ADDENDUM NO. 1

RFB#8517 LDLD Road Rehabilitation Project

SACRAMENTO AREA SEWER DISTRICT
 ECHOWATER RESOURCE RECOVERY FACILITY
 LDLD ROAD REHABILITATION PROJECT

CIVIL
PLAN-UTILITIES AREA A

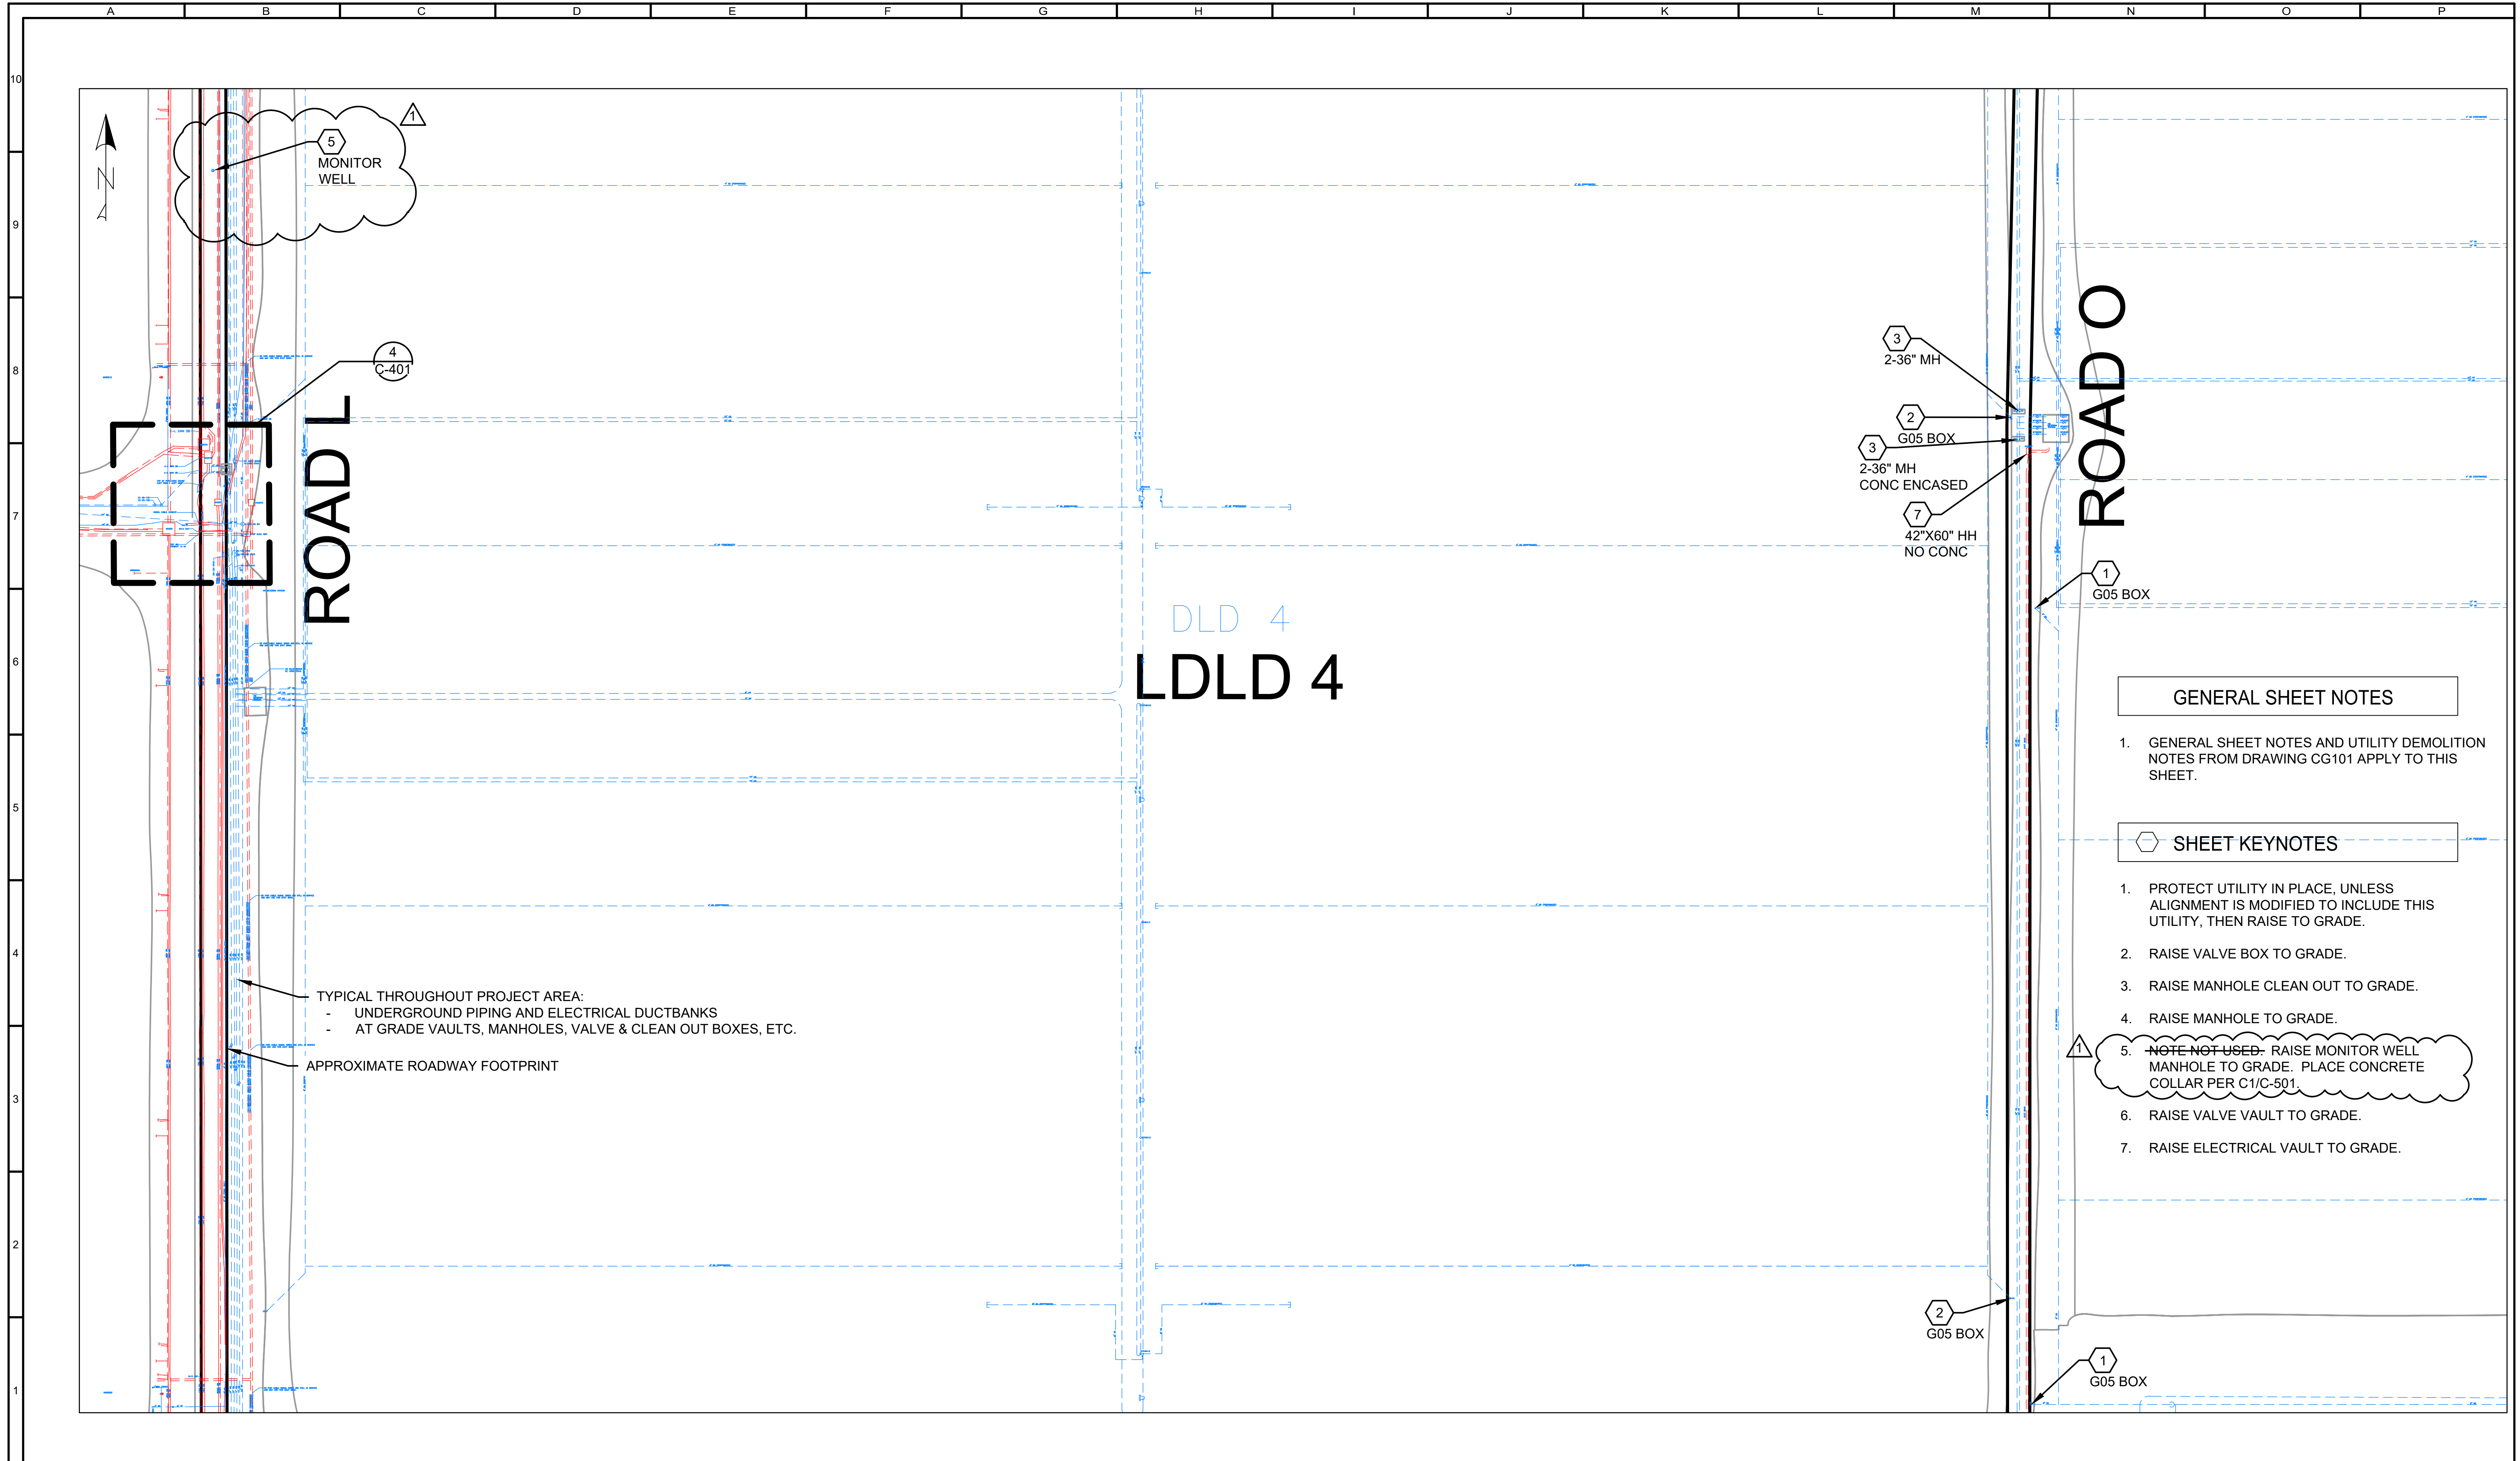
1.03	Volume 2 of 2 Drawing CG101	REPLACE Drawing CG101 PLAN-UTILITIES AREA A with attached Addendum 1 drawing dated 10/20/25.
1.04	Volume 2 of 2 Drawing CG103	REPLACE Drawing CG103 PLAN-UTILITIES AREA C with attached Addendum 1 drawing dated 10/20/25.

8. The Plan-Utilities sheets show vast amounts of existing utilities along the project alignment. This could require large quantities of potholing depending on the depths of these existing utilities. Please provide a bid item and quantity for Potholing to bring all the bidders on the same page. If a qty will not be given, please provide as-built profiles that show depths to help us discern the proper number of potholes required. If profiles are not available, please provide a list of the average depths of each type of utility line.

See Underground Utility & Pothole Notes on addendum item 1.03.

UNDERGROUND UTILITY & POT HOLE NOTES

TYPICAL APPROXIMATE UTILITY DEPTHS ARE INDICATED BELOW:

- WET UTILITIES INCLUDING BUT NOT LIMITED TO: DS, HS, SD, SE, SN, WP, WN, WRH, ETC. ARE AT A MINIMUM 36" DEPTH BELOW GRADE.
- SIGNAL DUCT BANKS ARE AT A MINIMUM 24" DEPTH BELOW GRADE.
- 480V DUCT BANKS ARE AT A MINIMUM 24" DEPTH BELOW GRADE.
- 12KV DUCT BANKS ARE AT A MINIMUM 36" DEPTH BELOW GRADE.

POTHOLE REQUIREMENTS SHALL BE PER THE SACRAMENTO COUNTY STANDARD SPECIFICATIONS, SECTION 6-11 WITH THE FOLLOWING EXCEPTION: THE REQUIREMENT TO "POTHOLE AT 25-FOOT INTERVALS, AT EACH CHANGE OF DIRECTION, AND AT EVERY SERVICE LINE OR LATERAL" IN SECTION 6-11.01/BULLET ITEM 4 SHALL BE WAIVED. INSTEAD, THE CONTRACTOR SHALL ASSUME THAT POT HOLLING WILL BE REQUIRED AT A MINIMUM OF 15 LOCATIONS THROUGHOUT THE PROJECT. TYPICALLY 2 PER SEGMENT OF ROAD OR AS NEEDED PER COORDINATION WITH THE DISTRICT* AS FOLLOWS:

- ROAD N - NORTH & SOUTH (2 TOTAL)
- ROAD D - EAST & WEST (2 TOTAL)
- ROAD O - NORTH & SOUTH (2 TOTAL)
- ROAD L - NORTH & SOUTH (2 TOTAL)
- ROAD G - EAST & WEST (2 TOTAL)
- ROAD F - EAST & WEST (2 TOTAL)
- AS NEEDED - ROAD J, M, OR *OTHER LOCATIONS (3 TOTAL)
